SUBJECT: Project ORACLE, Failure To Transfer Some Files  
From Disk to TBM Tape

SUBJECT : Project ORACLE

On 29 October 1975, [redacted] STATINTL  
of the Agency met with the [redacted] STATINTL representatives, [redacted] STATINTL and [redacted] STATINTL for the purpose of determining the direction and status of [redacted] STATINTL design of the ORACLE Mass Storage System. There were four areas discussed in detail that we felt were not being properly designed. We asked [redacted] STATINTL to tell us clearly what they were doing. The remainder of this paper is devoted to our understanding of the designs, their implications, commentaries and references that explain our concern, and a statement of our requirements for each design area.

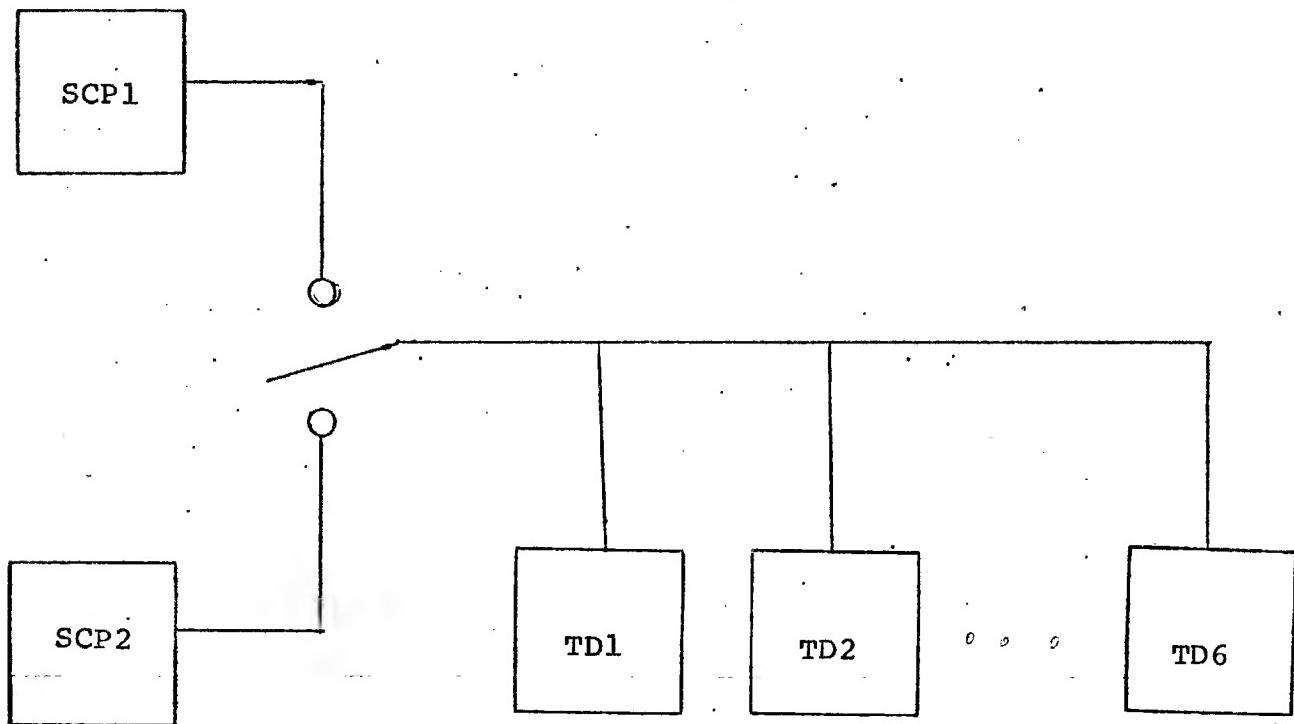
The Storage Control Processor (SCP) is a small computer that controls and initiates all functions that are performed by the Mass Storage System. There are two SCP's in the system. A Transport Driver (TD) is a hardware device that controls all of the function performed by Tape Transports. The current [redacted] STATINTL design permits one and only one Storage Control Processor (SCP) to be enabled at any given time to access any of the Transport Drivers (TD). The SCP's and TD's are cabled together in such a way that when one SCP is in control of the TD's, the other SCP is blocked from all access to any of the TD's by a hardware interlock. In order for the second SCP to gain access to the TD's, the first SCP must relinquish its control and then it is possible for the second one to take over. Once the second SCP is in control the first one is inhibited from all access to the TD's. Any interrupt issued by a TD is serviced by whichever SCP is currently in control. The TD does not know which SCP should handle the interrupt, it is expected in this design that this type of problem can be adequately solved at the SCP level. The drawing below illustrates how these hardware elements are tied together logically.

The above design gives control, at any given time, of all TD's to a single SCP. If dual SCP control of TD's is desired, the two SCP's could flip-flop by means of software logic. A flip-flop technique would permit segregating or sharing those functions in the two SCP's that require an SCP-TD association. Implementation of such a scheme adds complexity to the software logic which would have to reside in both SCP's. The areas particularly affected are hand-shaking protocols, timing, and recovery.

[ ] has chosen not to develop a flip-flop design. They have ruled out any type of dual SCP operation, the second SCP is for back-up only. The hardware design does not permit selective accessing of TD's by both SCP's concurrently and the software design requires that all accesses of TD's be made from only one SCP. There are advantages to the design chosen by [ ]. A single SCP controlling all the TD's needs only the simplest software.

1. The Storage Control Processors (SCP's) must be able to access the Transport Drivers (TD's) in such a manner that given redundancy of SCP's and TD's, no single failure will cause the entire Mass Storage System to be inoperable.
2. A stand-alone SCP must be able to access a TD so that a TBMTAPE can be initialized.
3. An SCP must have access to the TD's such that off-line maintenance of an SCP can be concurrent with on-line operation of the Mass Storage System.

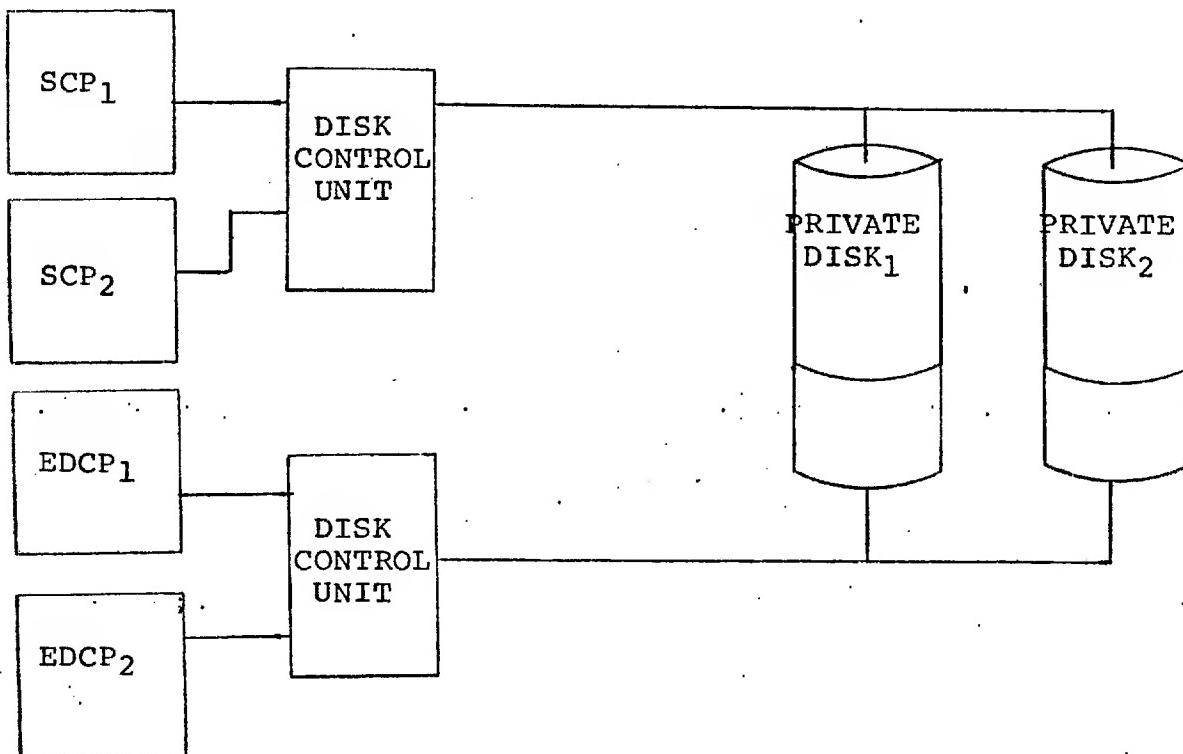
The Storage Control Processors (SCP's) and the External Data Channel Processors (EDCP's) are the MSS hardware modules that access these private disks. Presently, [redacted] has designed the software such that the SCP's require a dedicated disk control unit to access the private disks. Dedicated here, means that only the SCP's can use the control unit. When the EDCP's require access it must be gained via another control unit.

The figure below shows the [redacted] design.

The use of a dedicated controller by the SCP's requires that a second one be made available in the event the first one fails. If this were not done the failure would result in the MSS being inoperable. Thus the impact of the [redacted] design is limited to the additional funds required for a spare controller and the space needed for its placement.

Access to the private disks of the MSS must be provided by disk control units that are shared among the SCP's and EDCP's as specified in the Mass Storage System Design (Specification) dated March 19, 1975.

Figure 3. ORACLE BSS Configuration, Oct - Dec, 1975

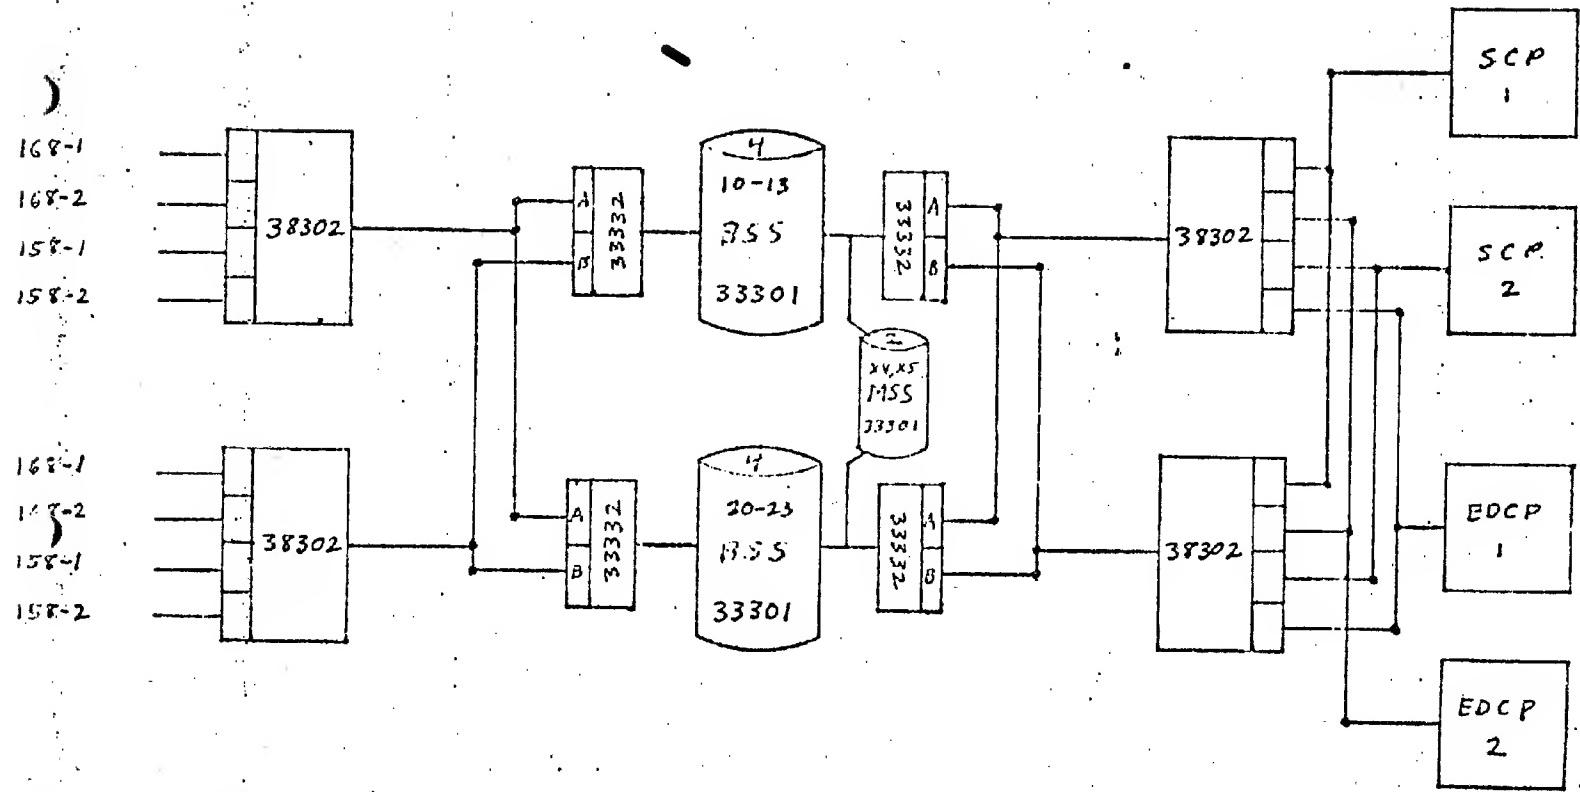
The above figure shows two disk control units to provide all EDCP's and SCP's with access to the private disks. There is no control unit allocated specifically for the SCP's.

Reference: [REDACTED] Proposal, Page 2-19, Figure 2.1.11

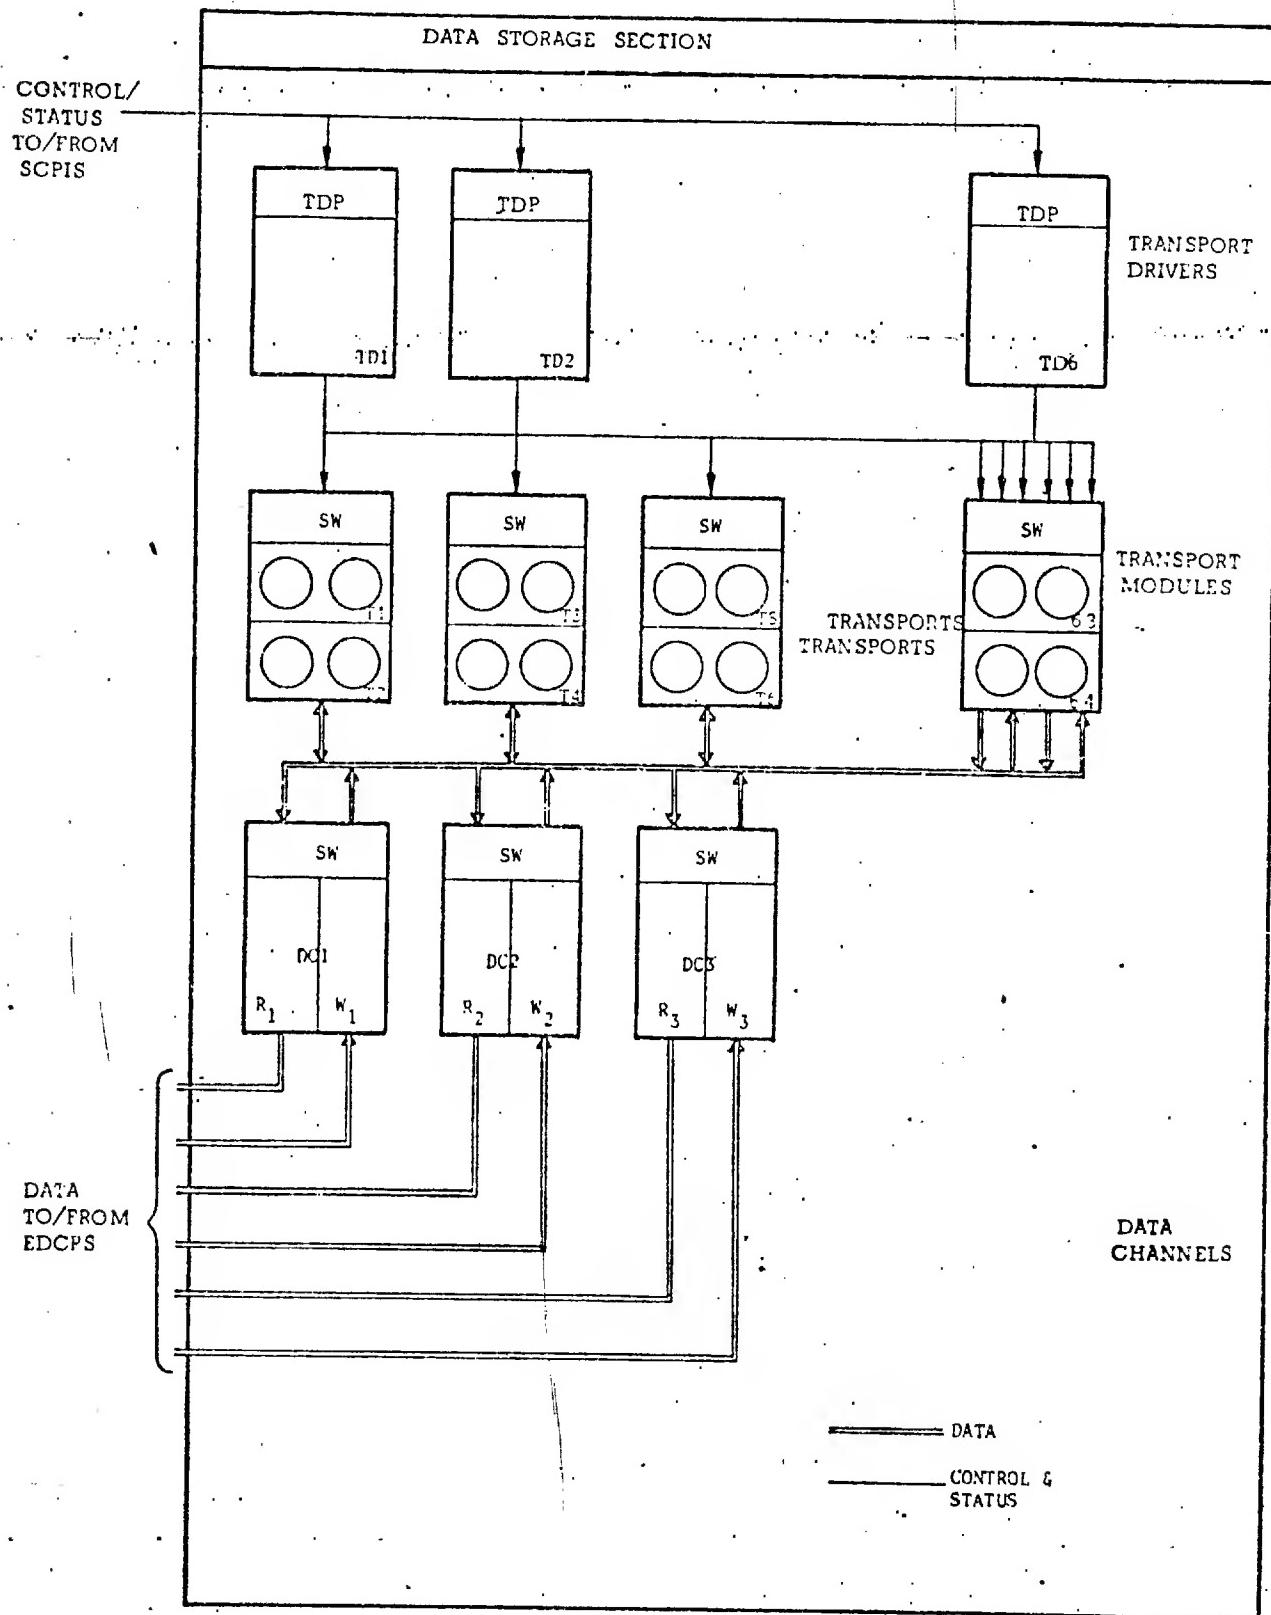
"The hardware modules and the interconnecting switching matrices are described below, and depicted in Figures 2.1.10 and 2.1.11." Inspection of the figure shows that the TD's (up to 6) can access any of up to 64 tape Transports. It also shows the 3 DC's accessing any of the 64 tape Transports. Finally, it shows the 3 DC's servicing 6 EDCP's.

STAT      Figure 2.1.11 when related to all the recorded statements by [redacted] shows:

- a. Maximums of 6 TD's, 64 Transports, 3 DC's, and 6 EDCP's.
- b. Perfect switching or accessing between related devices.

I feel there is a case to ask [redacted] to provide perfect STATINTL switching for the maximum system configuration of 6 TD's, 64 Transports, 3 DC's and 6 EDCP's. The weakness in all of the above arguments comes from the lack of positive statements concerning the capabilities of the Data Channels' accessibility. However, in light of the failure of [redacted] STATINTL to make specific statements about the limitations of the DC's, it can be argued that it is entirely reasonable to conclude there are no limitations other than those implied by the maximums.
